REMARKS

Drawing Amendments

ANNOTATED REPLACEMENT SHEET

FIG. 7

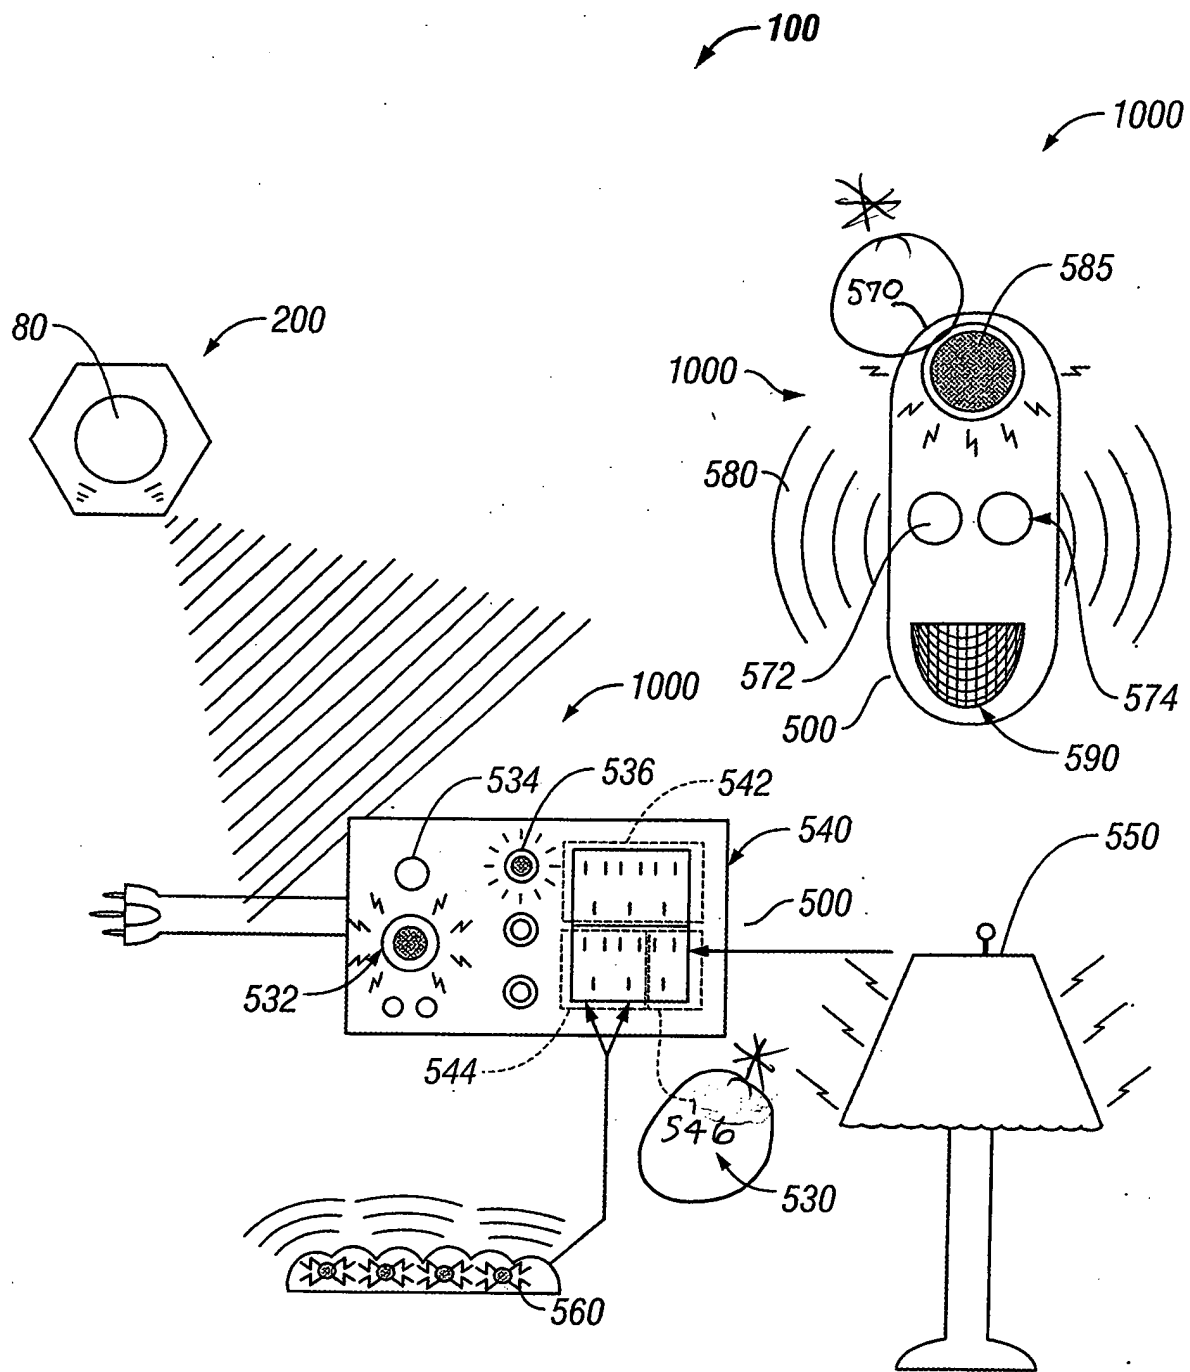
Figure 7 has been amended to make reference to the "blinking oscillating circuit 546" by correcting the reference originally labeled as 916.

Figure 7 has been amended to make reference to the "personal alarm system 570."

FIG. 9

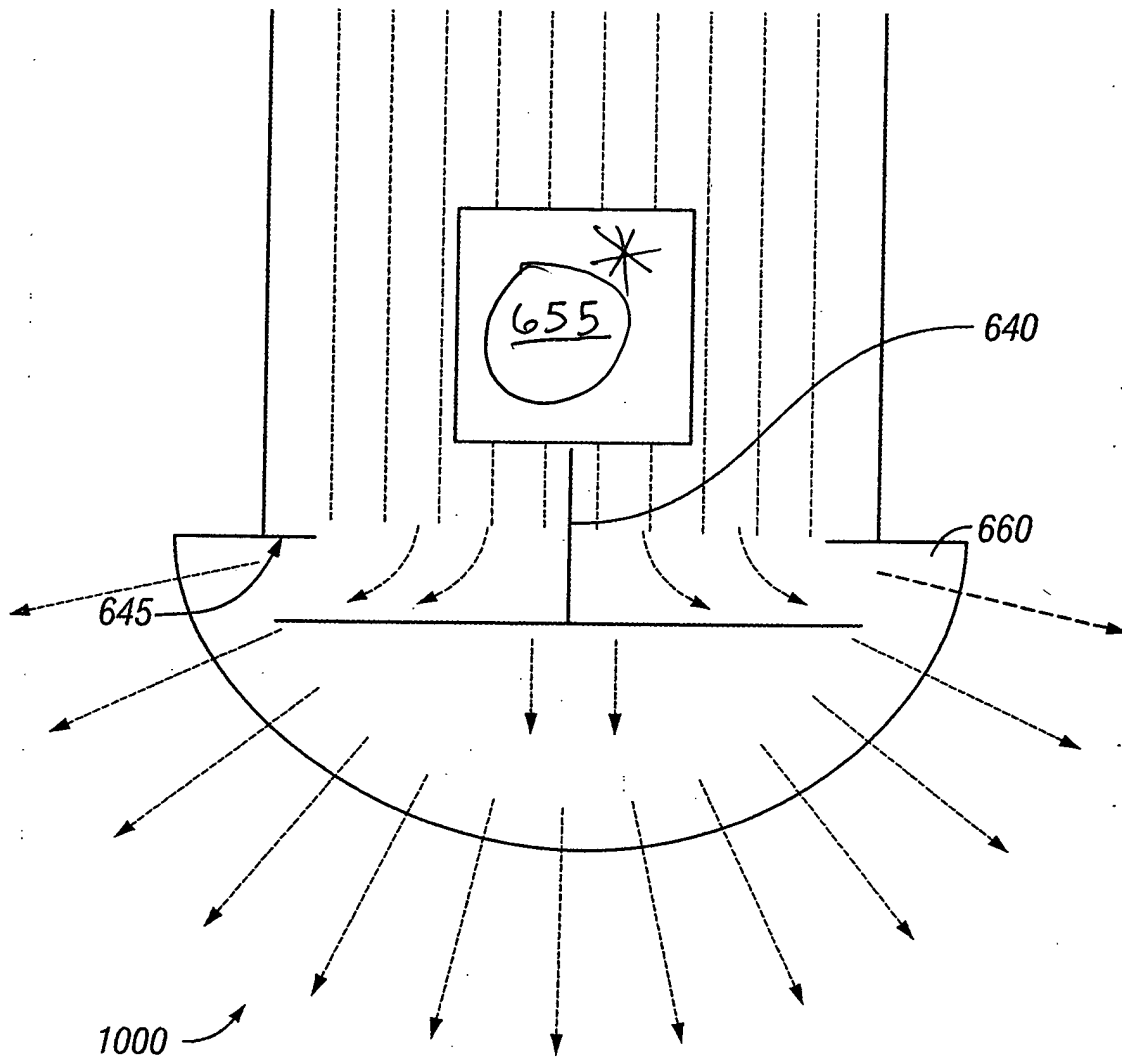
Figure 9 has been amended to make reference to "latch . . . solenoid 655."

FIG. 13

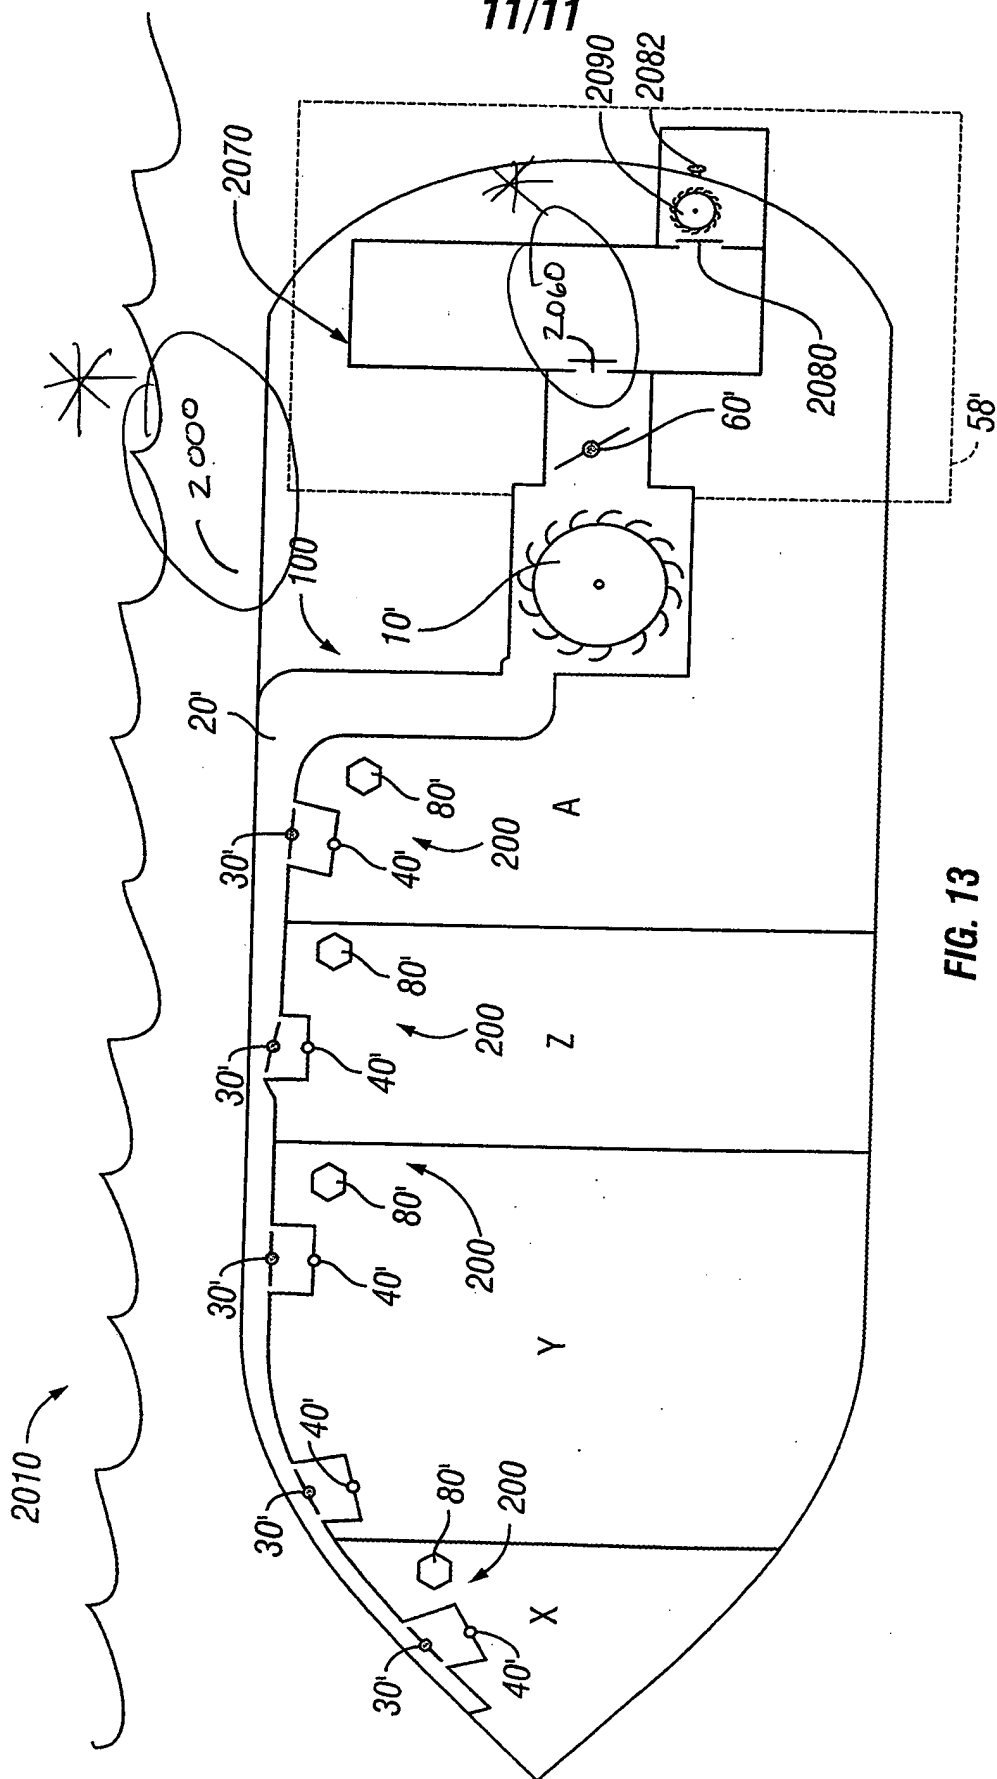
Figure 13 has been amended to make reference to "submergible submarine 2000" and "check valve 2060."
